H. B. ROBINSON STEAM ELECTRIC PLANT, UNIT NO. 2
DOCKET NO. 50-261
LICENSE NO. DPR-23
IE BULLETIN 80-11,
MASONRY WALL DESIGN

As requested by your letter dated October 4, 1982, Carolina Power & Light Company (CP&L) has completed the response to your request for additional information regarding IE Bulletin 80-11, Masonry Wall Design, for the H. B. Robinson Steam Electric Plant Unit No. 2 (HBR2).

CONCRETE MASONRY WALLS
RESOLUTION OF NRC QUESTIONS
ON IE BULLETIN 80-11

JUSTIFICATION OF RESPONSE ACCELERATIONS USED
IN THE DESIGN CALCULATIONS

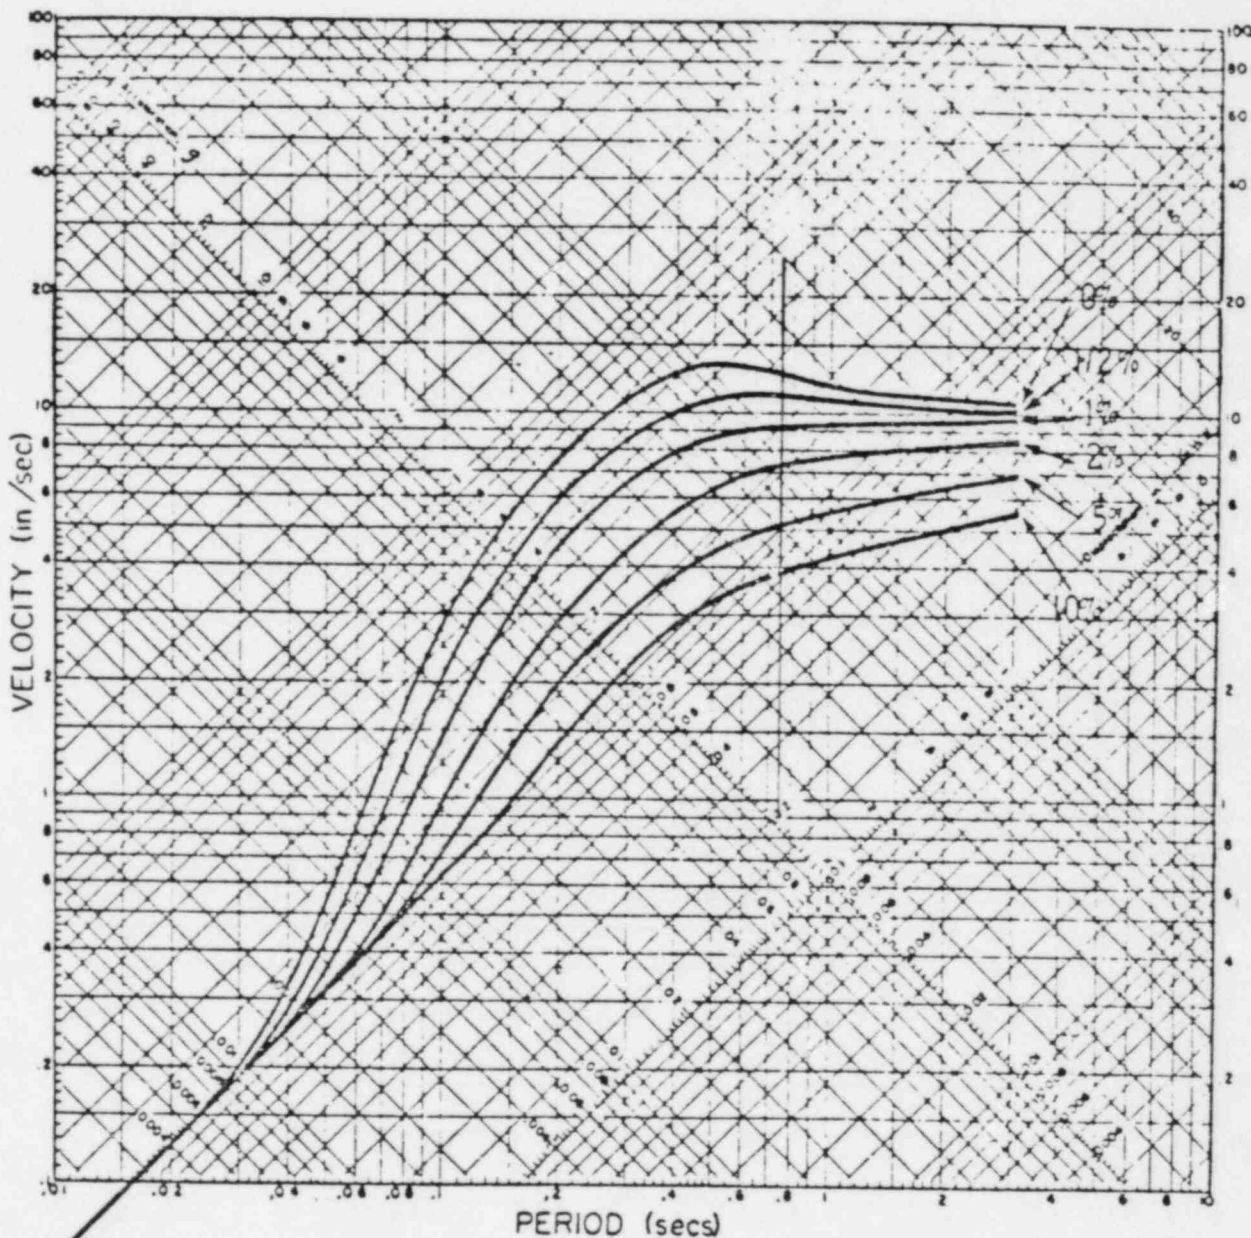
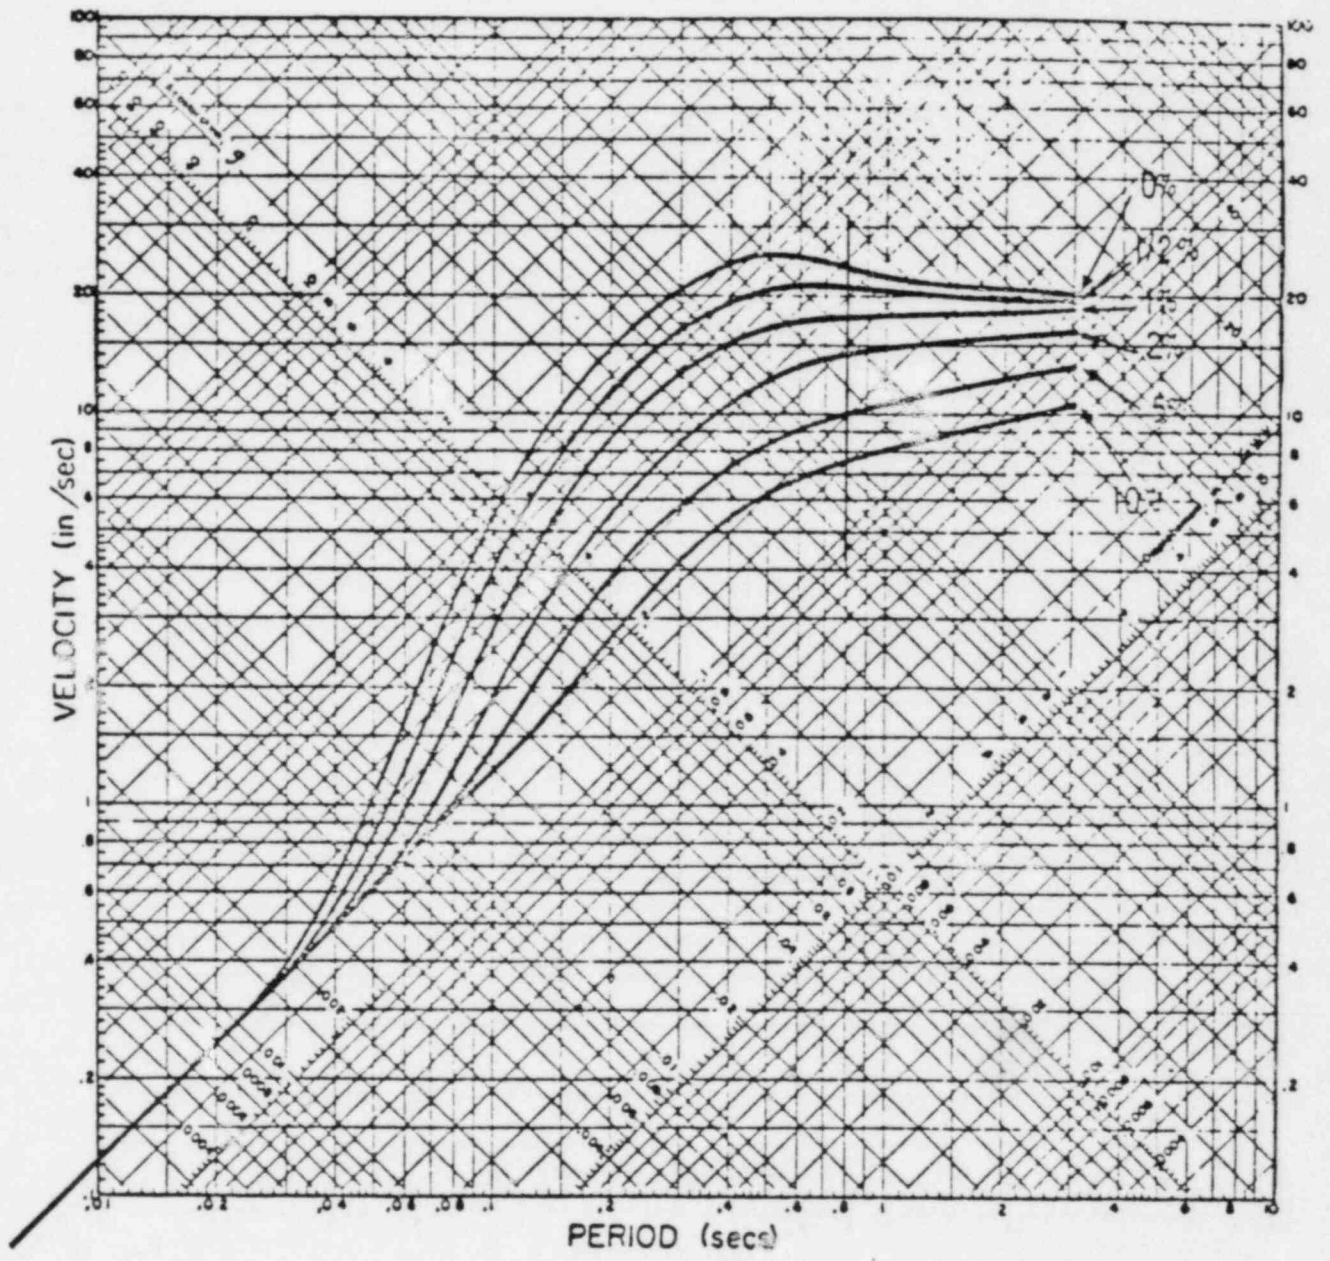
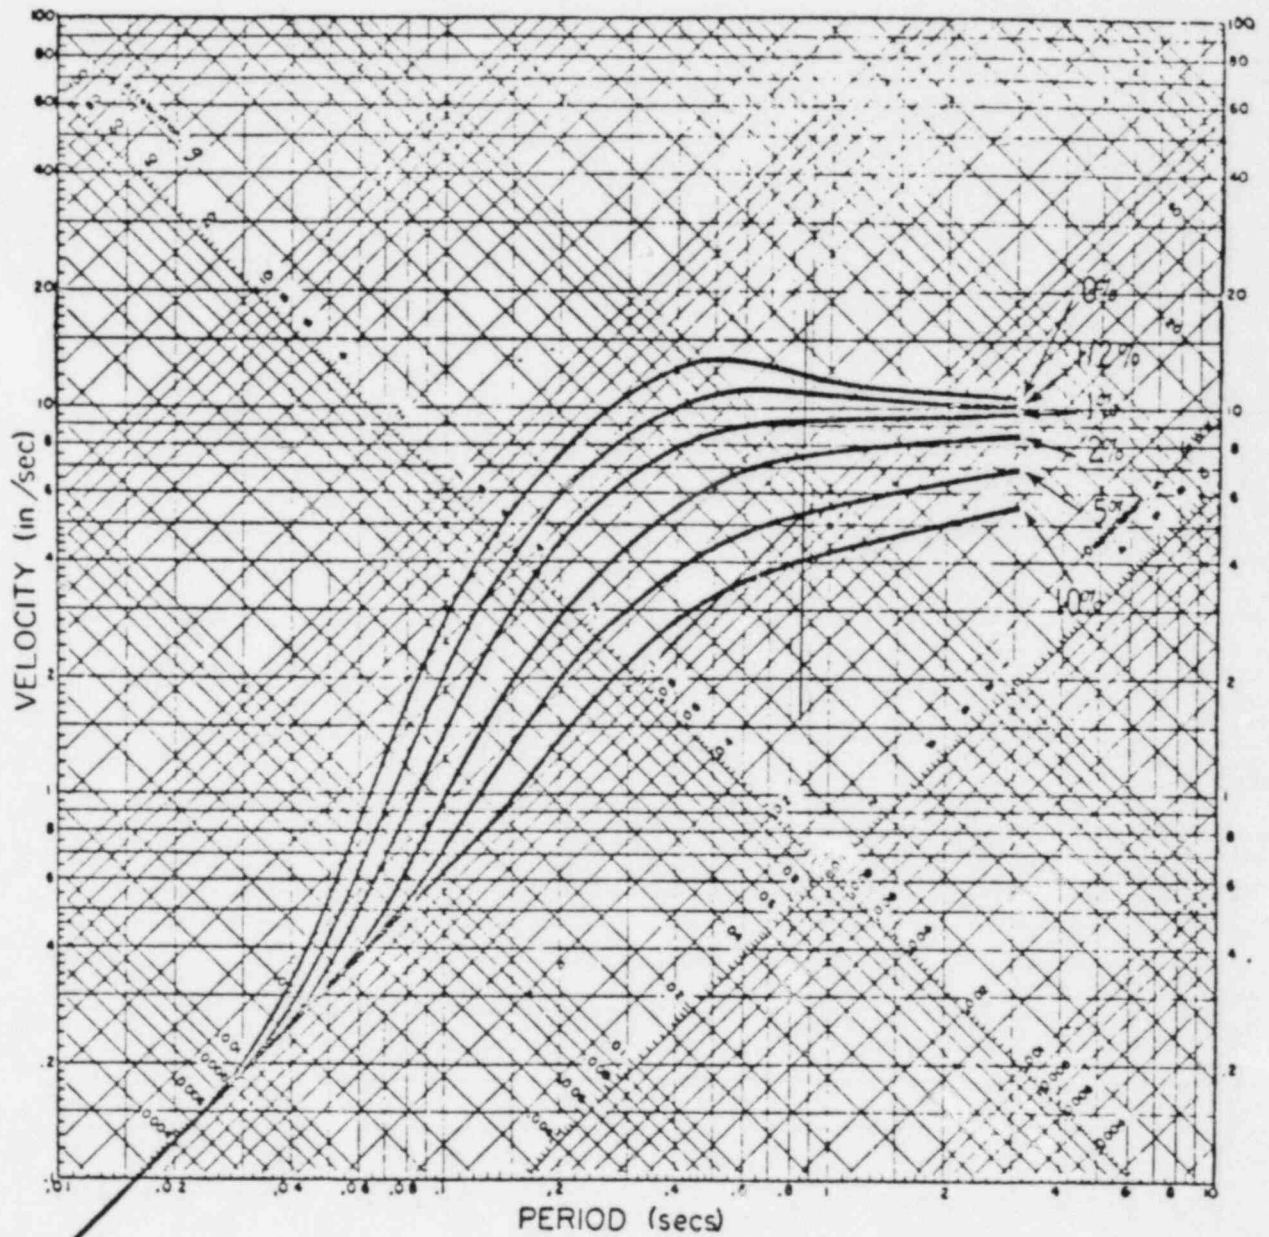
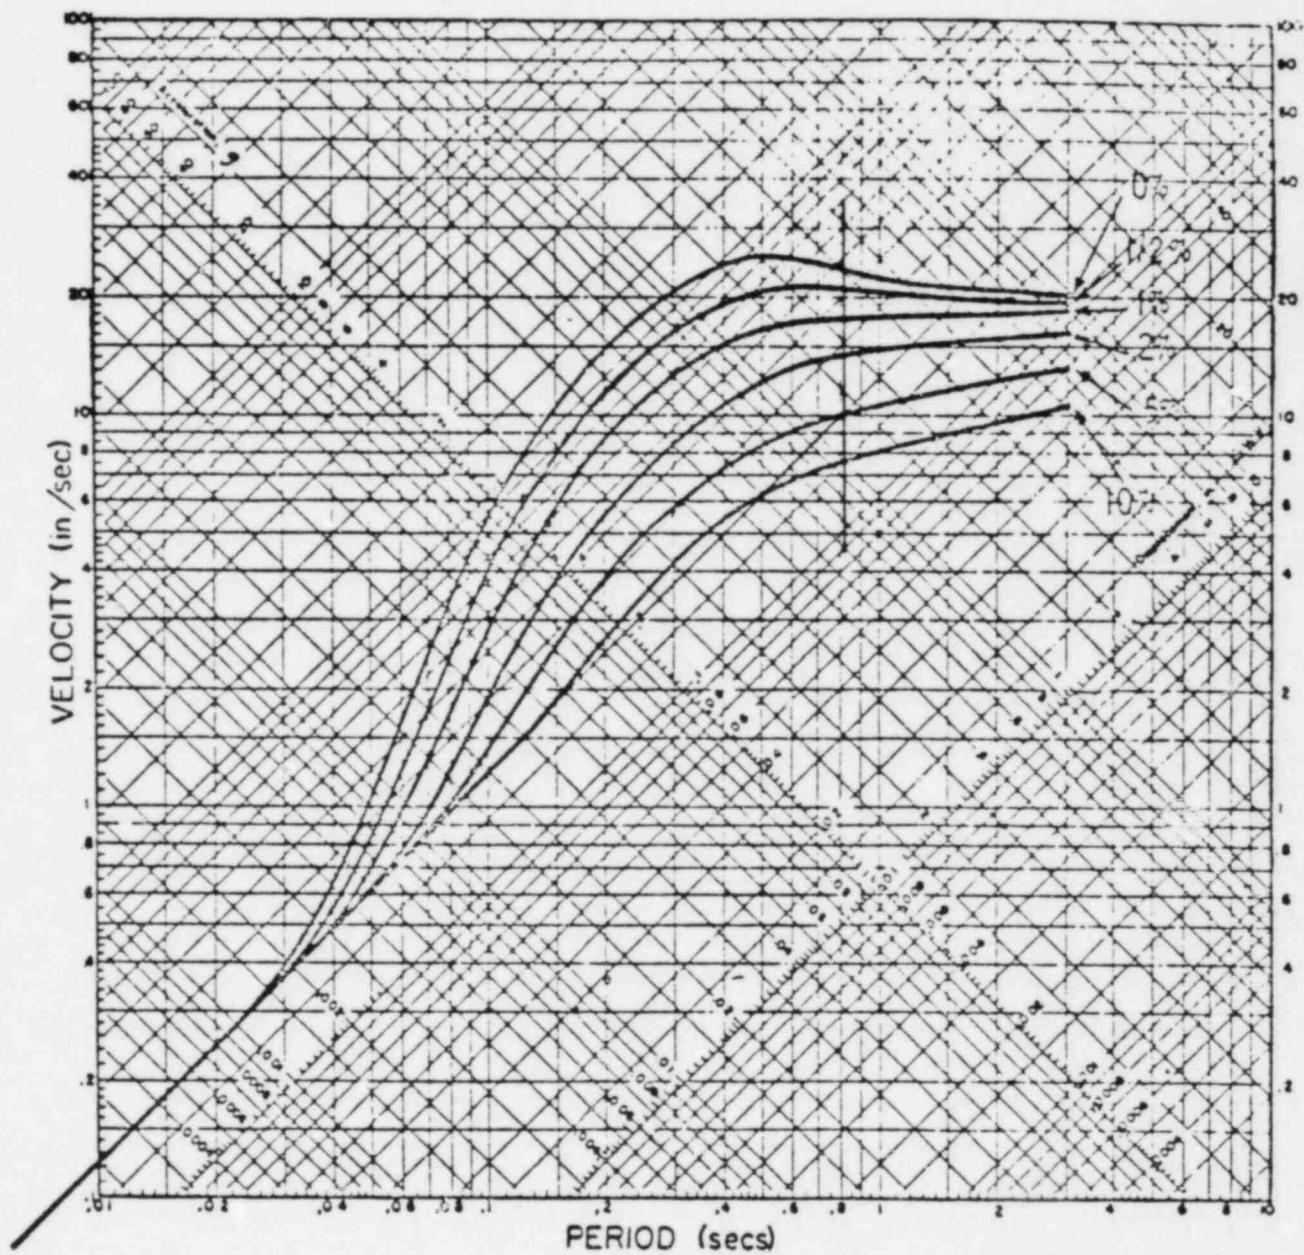
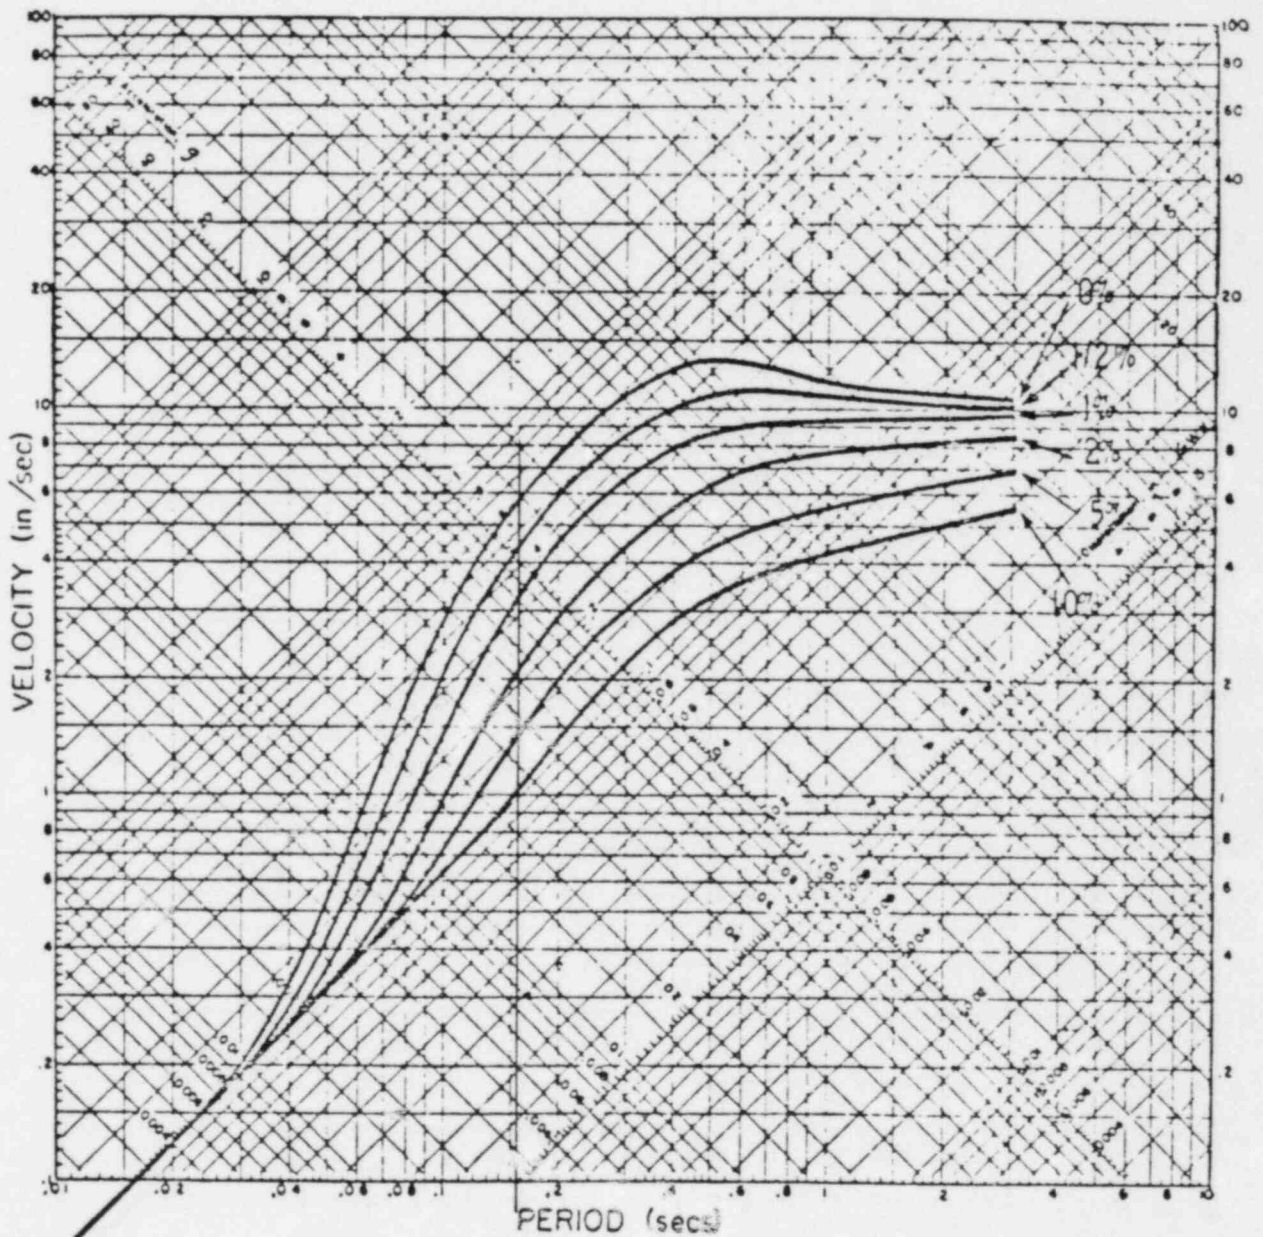
NRC Comment 10: Explain how seismic analysis was performed. Clarify whether acceleration values were selected from appropriate floor response spectrum. If not, provide justification and indicate whether the method used is consistent with the FSAR requirements.

Ebasco Response: An equivalent static analysis was performed for each wall. The analyses used a horizontal seismic acceleration factor of 0.2g, combined linearly with a vertical seismic acceleration of $2/3 \times \text{Horizontal} = 0.134g$.

From the seismic data in Appendix B of this report, we see that the accelerations from the appropriate floor response spectrum are (by using the NRC suggested damping factors specified in Regulatory Guide 1.61) lower than the assumed accelerations used in the analyses for the Fuel Handling Building and the Reactor Auxiliary Building.

- A. Reactor Auxiliary Building
 - 1. Operating Basis Earthquake-OBE (10% G)
at NRC suggested 4% damping, $g = 0.13$
 - 2. Design Basis Earthquake-DBE (20% G)
at NRC suggested 7% damping, $g = 0.18$

1. Operating Basis Earthquake-OBE (10% G)
at NRC suggested 4% damping, $g = 0.12$
2. Design Basis Earthquake-DBE (20% G)
at NRC suggested 7% damping, $g = 0.18$

1. Operating Basis Earthquake-OBE (10% G)
at NRC suggested 4% damping, $g = 0.17$
2. Design Basis Earthquake-DBE (20% G)
at NRC suggested 7% damping, $g = 0.25$

These horizontal accelerations (and associated vertical accelerations) are greater than the values used in the analysis of Wall 6. A review of the analysis of Wall 6 (included as a sample calculation in Appendix A) reveals that the designed modifications are capable of withstanding these higher acceleration values.
